CHANGE NOTICE NO. 12  
 TO  
 CONTRACT AGREEMENT NO. 071B5000240  
 between  
 THE STATE OF MICHIGAN  
 and

**CONTRACT CHANGE NOTICE NO. 13**  
**TO THE**  
**STATE OF MICHIGAN**  
**800 MHZ RADIO SYSTEM & TELECOMMUNICATIONS BACKBONE NETWORK**  
**CONTRACT NO. 071B5000240**  
**BETWEEN**  
**THE STATE OF MICHIGAN**  
**AND MOTOROLA, INC.**  
**DATED DECEMBER 8, 1994**

**CONTRACT CHANGE NOTICE NO. 12  
TO THE  
STATE OF MICHIGAN  
800 MHZ RADIO SYSTEM & TELECOMMUNICATIONS BACKBONE NETWORK  
CONTRACT NO. 071B5000240  
BETWEEN  
THE STATE OF MICHIGAN  
AND MOTOROLA, INC.  
DATED DECEMBER 8, 1994**

Figure 6 5 - Alternative Routing

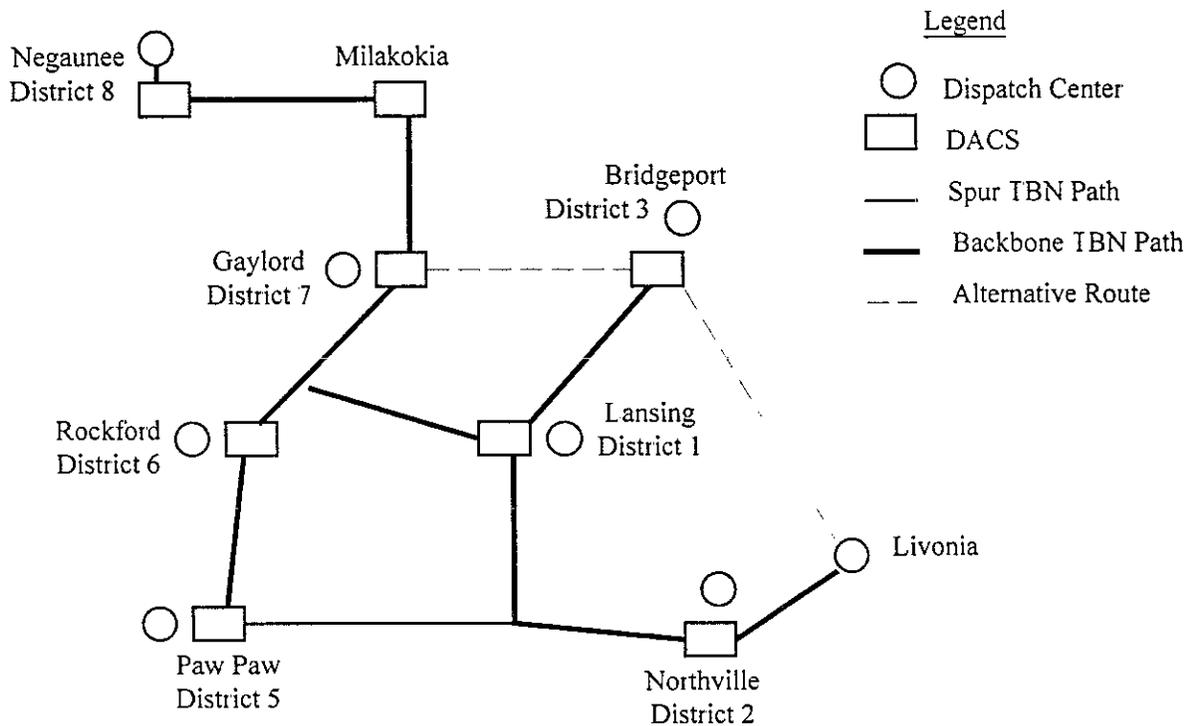
**6.2.2. Alternate Routing**

The System shall be implemented with the alternate routing capabilities as shown below. This option will be requested by the State at the time of Contract Release. The functional aspects of this alternate routing are shown below.

Figure 6.6 System Synchronization (CCO#10.2)

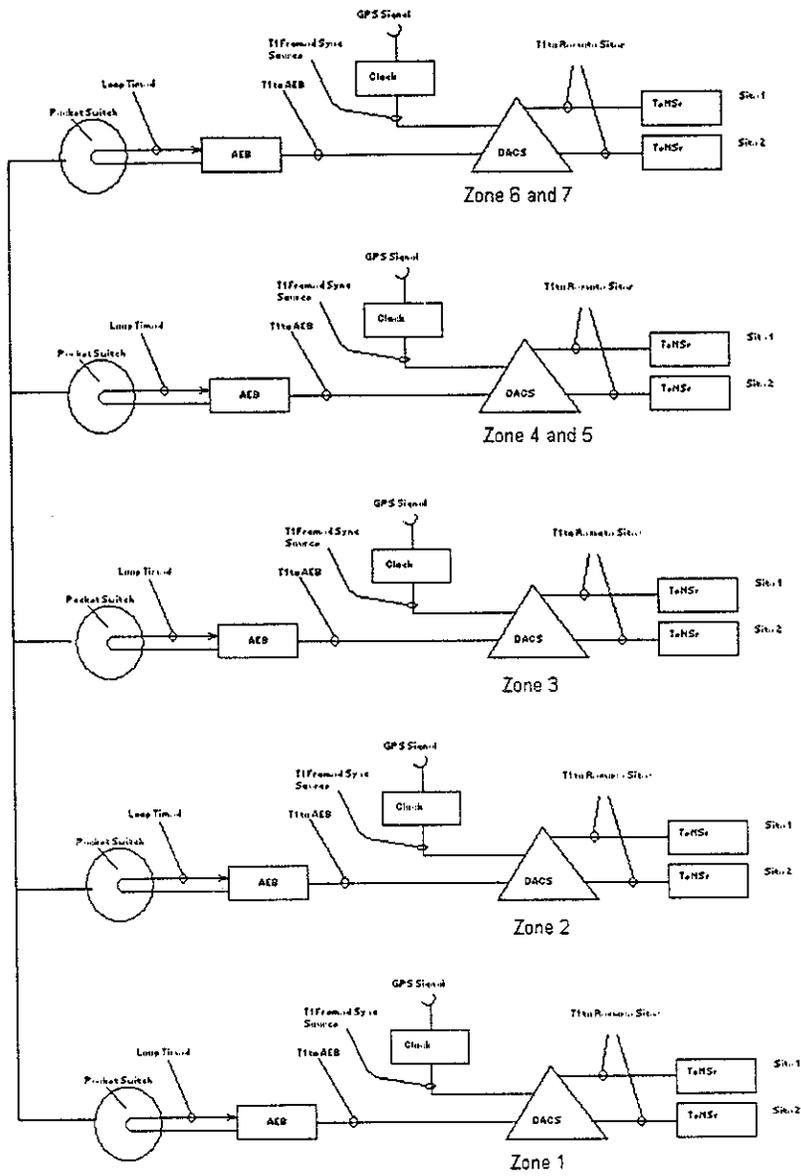
segregated (non master) DACS(s) in the same zone will then free run on their internal Stratum 3 Clock until the path is restored.

Clock Hierarchy is as follows: 1) Master Clock - Stratum-1 (GPS disciplined with Rubidium backup), 2) DACS - Stratum-3, and 3) Channel Bank - Stratum-4

Figure 6.7 - DACS Network Diagram

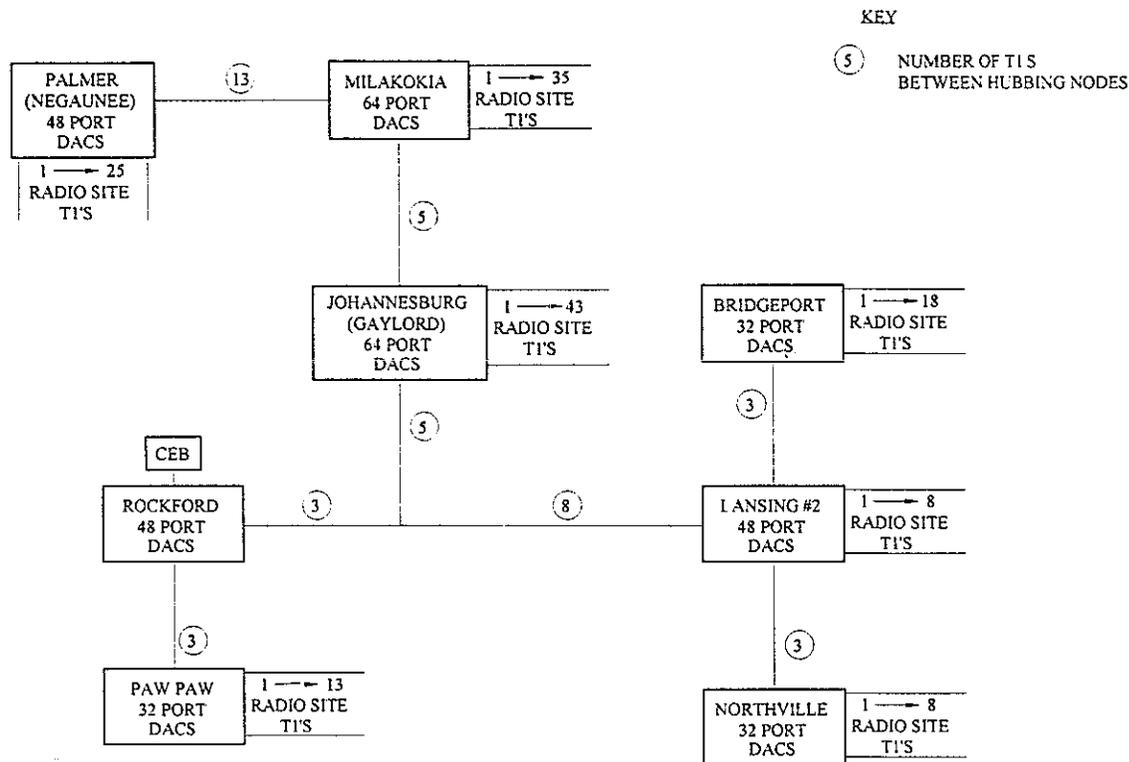
Minimum technical specifications for the DACS equipment shall be: 1) Port Capacity: equipped as shown in Figure 6.7 - Expandable to 128 ports. 2) DS-1 Line Interface: a) Line Rate: 1.544 Mb/s, b) DS-1 Frame Structure: D4/ESF selectable, c) DS1 Line Code: AMI/B8ZS selectable, 3) Administrative Port Interface: RS-232-C or RS-422, 4) Data Transfer Rate: Asynchronous full duplex 300, 1200, 9600 bps.

Figure 7.1 - System Network Management Diagram

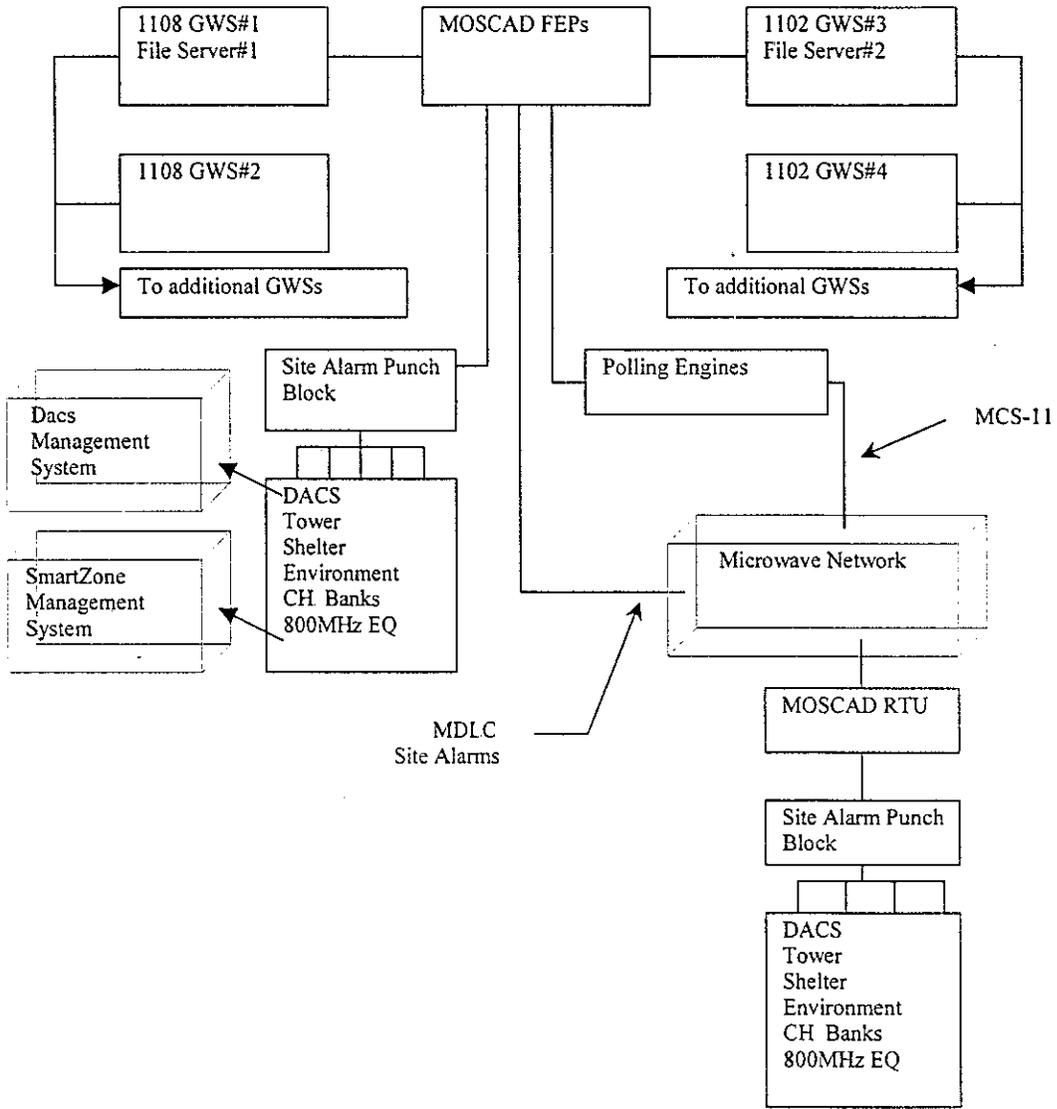
- 6) In Exhibit A delete Section 7.0 NETWORK MANAGEMENT, replace sections 7.1 through 7.2.4 with the following:

Figure 7.2 - Typical Alarms collected and reported

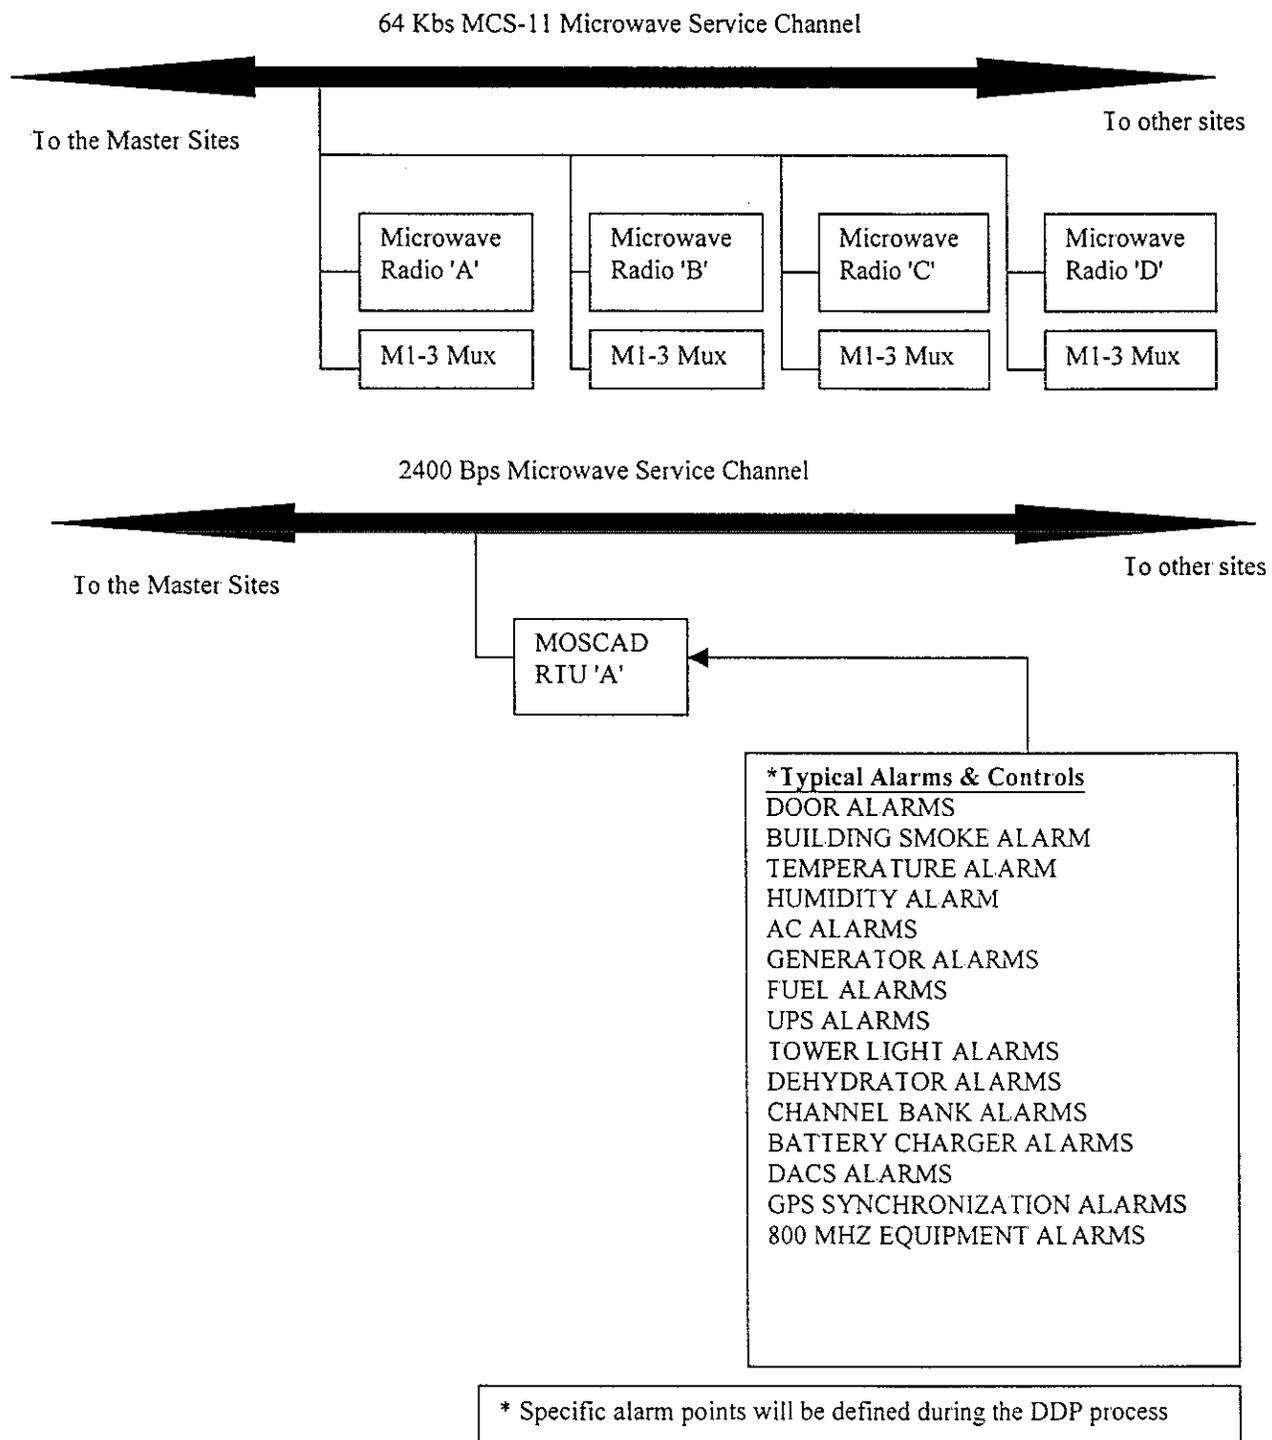
Each site shall have an intelligent Remote Terminal Unit (RTU). The RTU shall collect and report: alarms and status conditions to the master stations. The RTU shall also be capable of dry contact output controls. The data communications speed shall be at least 2400 Bps. The minimum number of alarms shall be 32 inputs and 8 digital control outputs. Sites with a Zone Controller shall be provided with additional alarm or control expansion modules. Sites required to monitor other devices such as QUANTAR stations, Trak® time standards, or Premisys™ channel banks shall be equipped with the appropriate additional modules

Guard Post (Bollard)

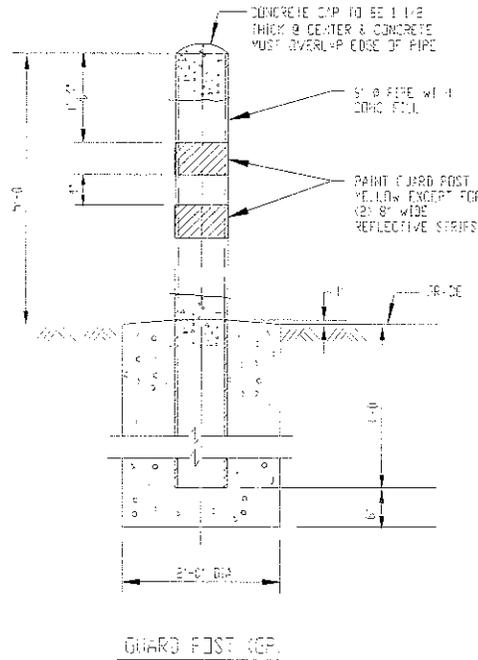
28.) In Exhibit A, add the following as a new section 8.7.1.:

Motorola shall furnish and install a Guard post (Bollard) at those sites selected by the State, per the Detailed Design Plan for that Phase. Pricing will be provided on a by Phase basis, and categorized as an SOM Addition

- One (1) 6" pipe with concrete fill.
- 6" pipe to be set in concrete and extend 5'-0" AFG, as shown and noted in detail below.
- Guard Post to be painted safety yellow, as shown and noted in detail below.
- Guard Post to include two (2) each 8" reflective safety strips, as shown and noted in detail below.

Figure 6.6 Synchronization Diagram

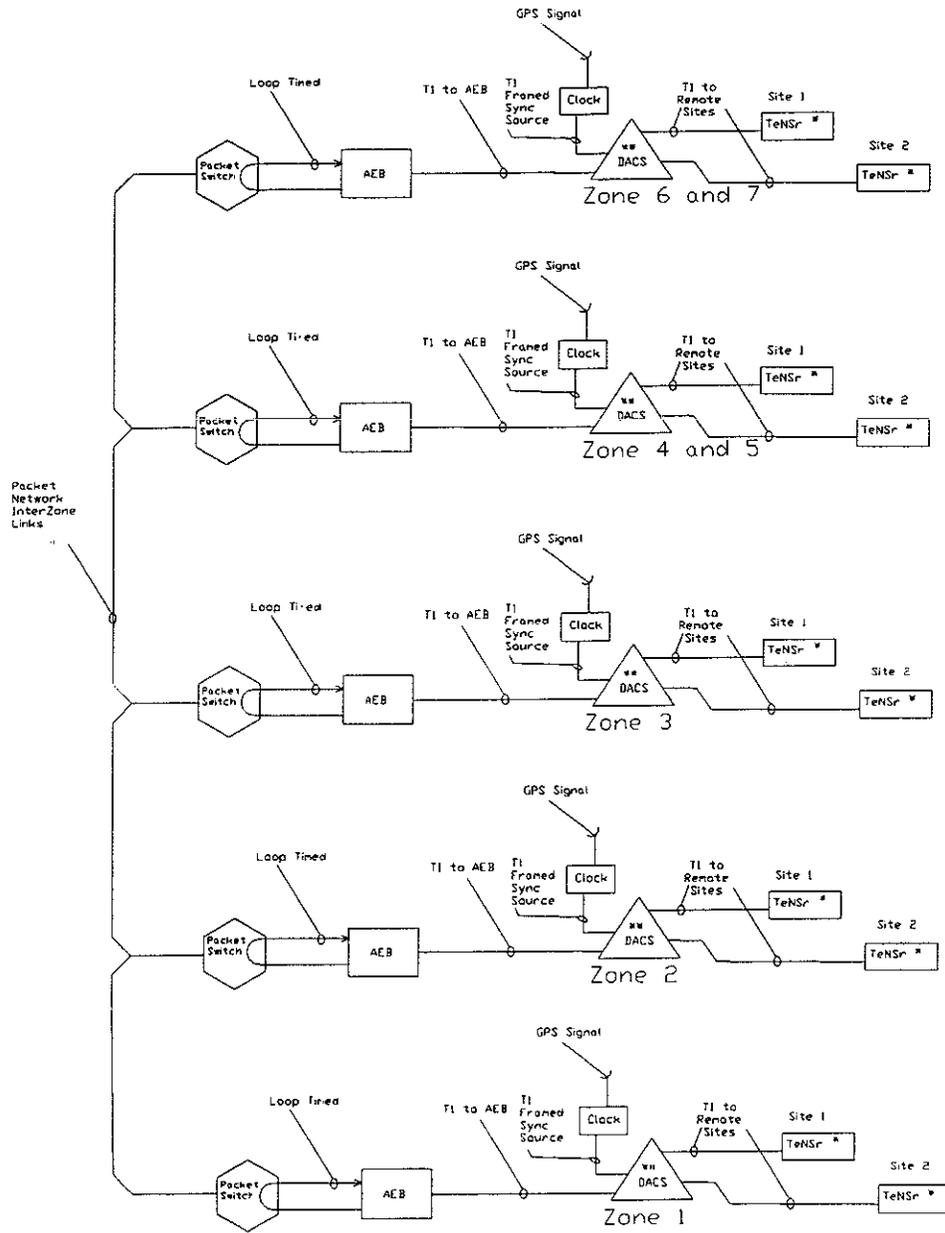
The output of each MFTS in each zone will feed the Primary and Secondary inputs of the master DACS in the associated zone. The zone shall then recover this clock for synchronization purposes via the T-1s. In the case of a GPS failure the Rubidium Oscillator will continue to keep synchronization until GPS tracking can be re-established. The Rubidium will maintain stability at  $\pm 2 \times 10^{-11}$  while free running (undisciplined). During a Rubidium Failure the Master DACS will revert back to its internal Stratum 3 free run clock. During Path failures the segregated (non master) DACS(s) in the same zone will then Free Run on their internal Stratum 3 Clock until the path is restored.

Clock Hierarchy is as follows: 1) Master Clock - Stratum-2 (1 slip every 132 hours), 2) Slave Clock - Stratum-3 (255 slips every 24 hours), and 3) Channel Bank - Stratum-4 (1 slip every 4 seconds).
